B 3.1 REACTIVITY CONTROL SYSTEMS

B 3.1.1 SHUTDOWN MARGIN (SDM)

Comment: According to the Conversion Comparison Table, "MODE 2 with $K_{eff} < 1.0$ " and "MODE 5" are added to the Applicability section of TS 3.1.1 for Comanche Peak and Diablo Canyon. All of the FLOG ITS Sections 3.1.1 have these applicability requirements included in the ITS and not in the CTS. Provide a discussion for Comanche Peak and Diablo Canyon explaining/justifying these changes.

FLOG RESPONSE: In the CTS, shutdown margin is controlled via LCO 3.1.1.1 for MODES 1, 2, 3 and 4, and LCO 3.1.1.2 for MODE 5. Rod insertion limits are controlled by LCO 3.1.3.5 for shutdown rods, MODES 1 and 2, and LCO 3.1.3.6 for control rods, MODES 1 and 2. When the reactor is critical (MODE 1 and MODE 2 with $K_{eff} \geq 1.0$), shutdown margin is assured, via the CTS, by assuring that rod insertion limits are met (see SR 4.1.1.1.16.) When the reactor is not critical (MODE 2 with $K_{eff} < 1.0$, MODE 3, MODE 4 and MODE 5), shutdown margin is assured by assessing boron concentration, temperature, etc. (see SR 4.1.1.1.1e and 4.1.1.2). The CTS requirements have been clarified and reorganized such that the rod insertion limits and

Figure B 3.1.7-1 (page 1 of 1)
Control Bank Insertion vs. Percent RTP

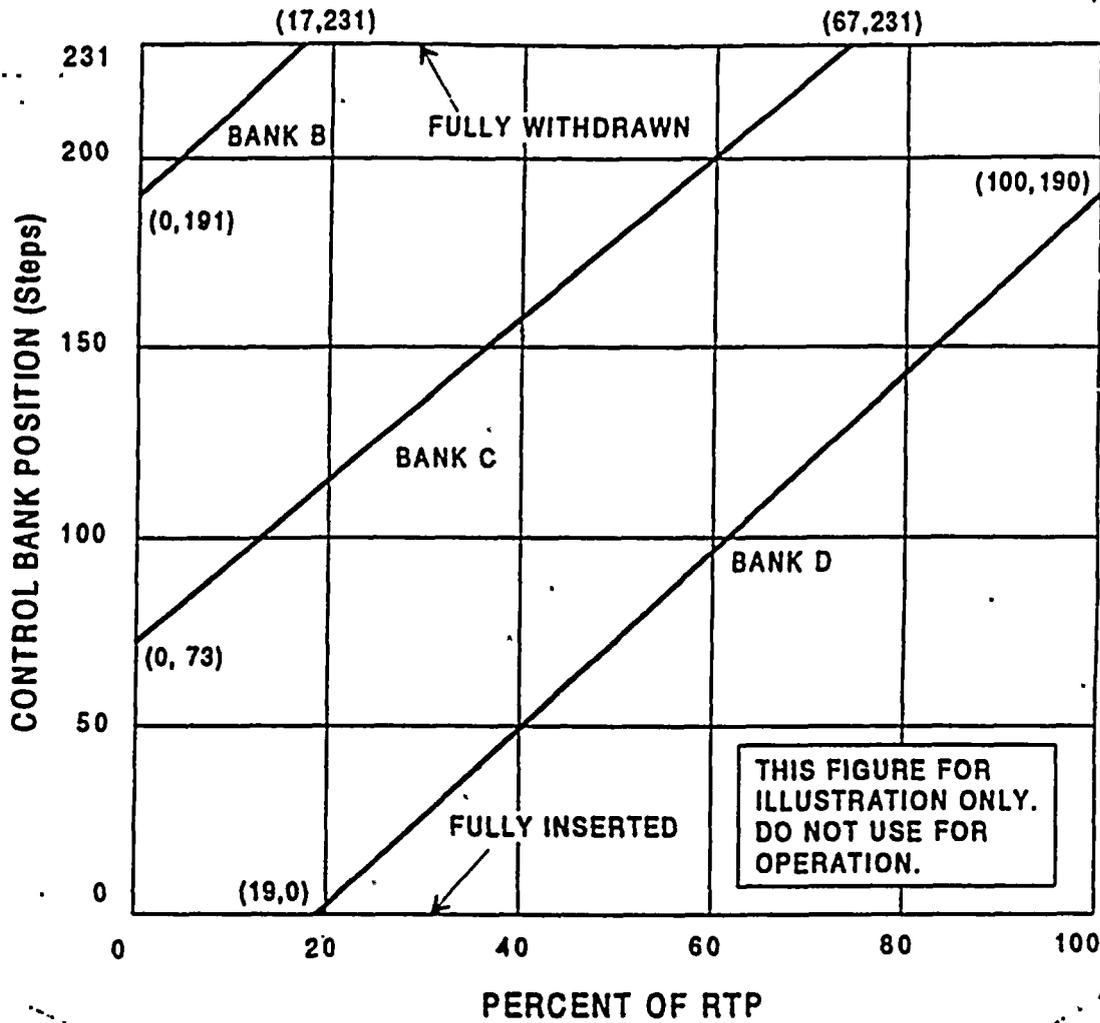
~~Figure B 3.1.7-1~~ The COLR also indicates how the control banks are moved in an overlap pattern. Overlap is the distance traveled together by two control banks. ~~The predetermined position of control bank C, at which control bank D will begin to move with bank C on a withdrawal, will be at 118 steps for a fully withdrawn position of 231 steps. The fully withdrawn position is defined in the COLR. The control banks are used for precise reactivity control of the reactor. The positions of the control banks can be controlled manually, or automatically by the Rod Control System. They are capable of altering reactivity very quickly (compared to borating or diluting).~~

Show Figure B3.1.7-1
as struck-out

The control bank insertion limits are specified in the COLR. ~~An example is provided for information only in Figure B 3-1.7-1.~~ The control banks are required to be at or above the insertion limit lines.

06-01 R The CTS 3.1.2.1, "Boration Flow Path Shutdown," and associated SR 4.1.2.1 are relocated outside of the TS. This is consistent with NUREG-1431. *Insert Q3.1-6*

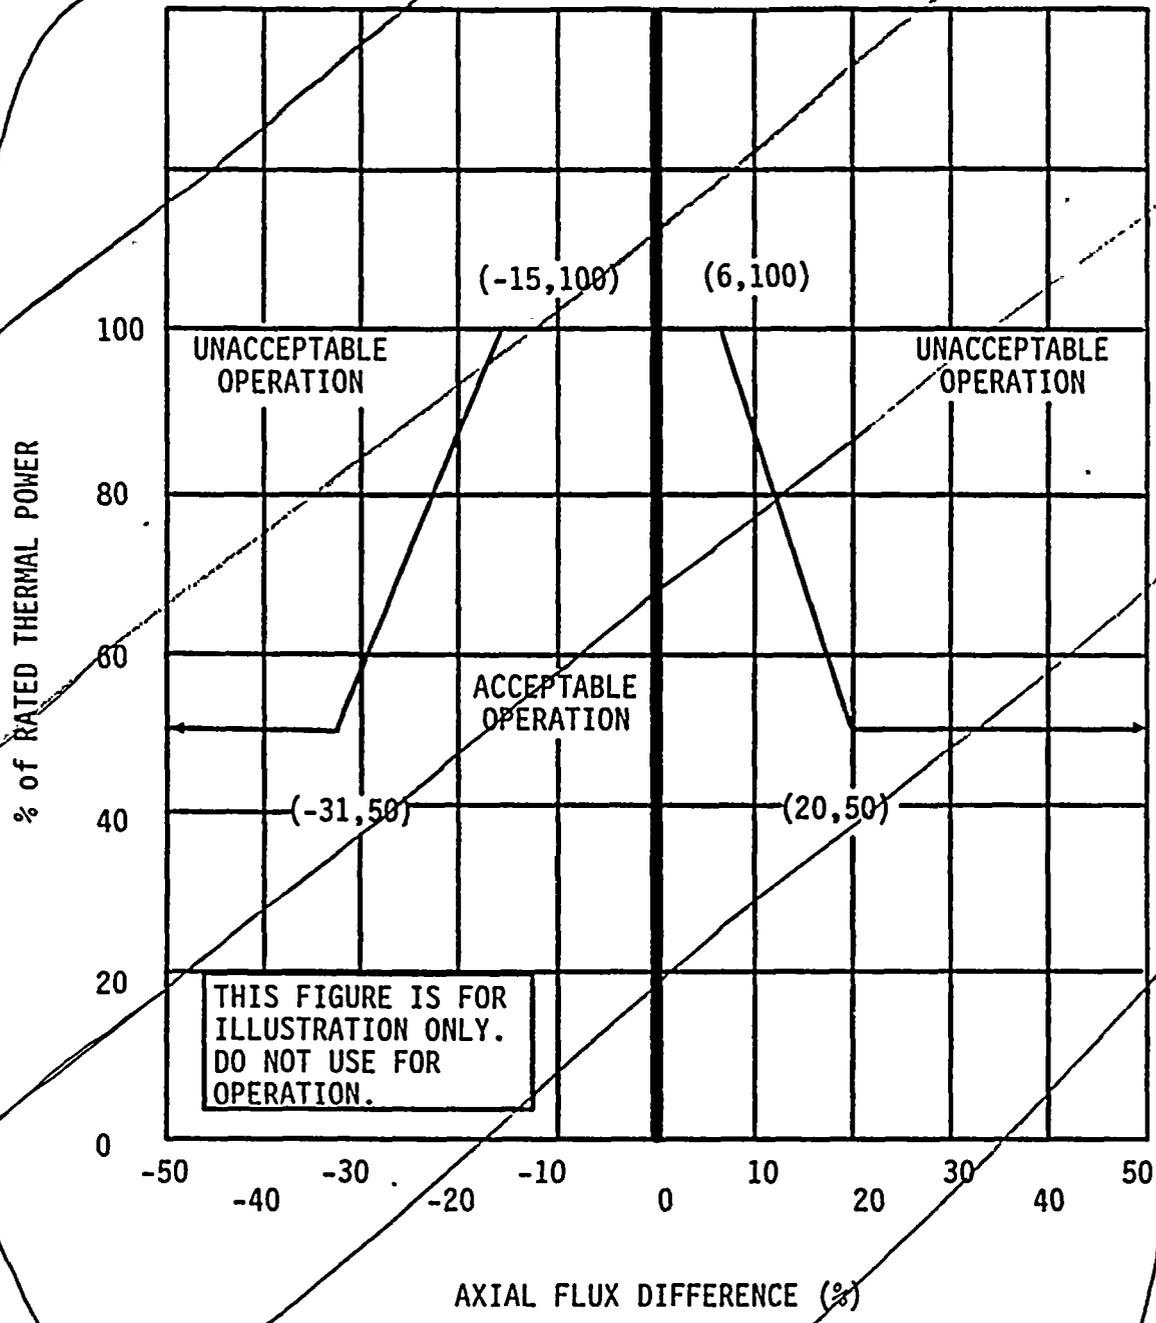
The AFD limits are provided in the COLR. ~~Figure B 3.2.3B-1 shows typical RAOC AFD limits.~~ The AFD limits for RAOC do not depend on the target flux difference. However, the target flux difference (AFD) may be used to minimize changes in the axial power distribution. *redline*
